Rebuttal to Patrick Jones Regarding Rifle Range Safety
By Edward B. Wilkes October 30, 2024

This paper rebuts the arguments made by Patrick Jones in paragraph 45 of the “Verified Answer” his attorney (Shon Northam) filed with the Court in response to the lawsuit filed by the Anderson/Millville Residents. See Addendum 2 of this paper for background regarding this lawsuit.

Addendum 1: Rifle Range Backstop Calculations

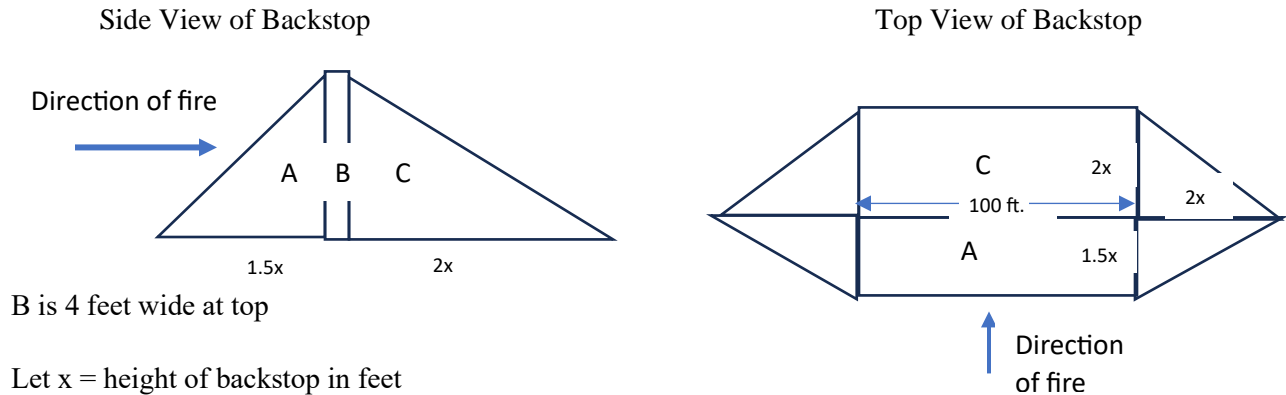
Given: Worst case (largest bullet drop) ballistics data from manufacturers for ammunition/rifles shown in paragraph 2: bullet drop for 300-yard range = 30 inches (round to 3 feet) and for 500 yard range = 140 inches (round to 12 feet). Assume 600 yard range bullet drop of 15 feet.

- Find:**
- 1) height of backstop for each range to capture round shot at 15° elevation (AR01675)
 - 2) required cubic yards of dirt to achieve backstop, using same design as proposed by Butler Engineering for 20-foot high backstops (AR00120).
 - 3) Number of dump truck loads of dirt to construct backstop, assuming each truck = 10 cubic yards
 - 4) Time to build each backstop, assuming 1 dump truck load of dirt every 15 minutes, 12 hours/day (48 truckloads per day), 7 days/week, no holidays.

B is 4 feet wide at top

Let x = height of backstop in feet

For 300 yard rifle range: $x = (\tan 15^\circ)(900') = 241'$ – bullet drop of 3 feet = 238 feet

For 500-yard rifle range $x = (\tan 15^\circ)(1500') = 402'$ – bullet drop of 12 feet = 390 feet

For 600-yard rifle range $x = (\tan 15^\circ)(1800') = 482'$ – bullet drop of 15 feet = 467 feet

Looking at the Side View diagram above: Area of cross section of backstop:

$$[(0.5)(1.5x)(x)] + 4'x + [(0.5)(2x)(x)] = 0.75x^2 + 4'x + x^2 = 1.75x^2 + 4'x$$

$$\text{Volume of backstop ABC (not including end ramps)} = (100')(1.75x^2 + 4'x)$$

Because of the height of the backstop, the left and right ends of the backstop must also be tapered.

Making the simplifying assumption that the 4' top is inconsequential, then the ends of the backstops can each be considered as $\frac{1}{2}$ of a regular pyramid. Regular pyramid volume = $[\frac{1}{3}] \{\text{area of base}\} [\text{height}]$.

Then one regular pyramid volume = $[\frac{1}{3}] \{[2][(0.5)(1.5x)(2x) + (0.5)(2x)(2x)]\} [x] = [\frac{1}{3}] \{7x^2\} [x] = (\frac{7}{3})x^3$

Then volume of backstop in cubic feet = $[(100')(1.75x^2 + 4'x)] + [(\frac{7}{3})x^3]$
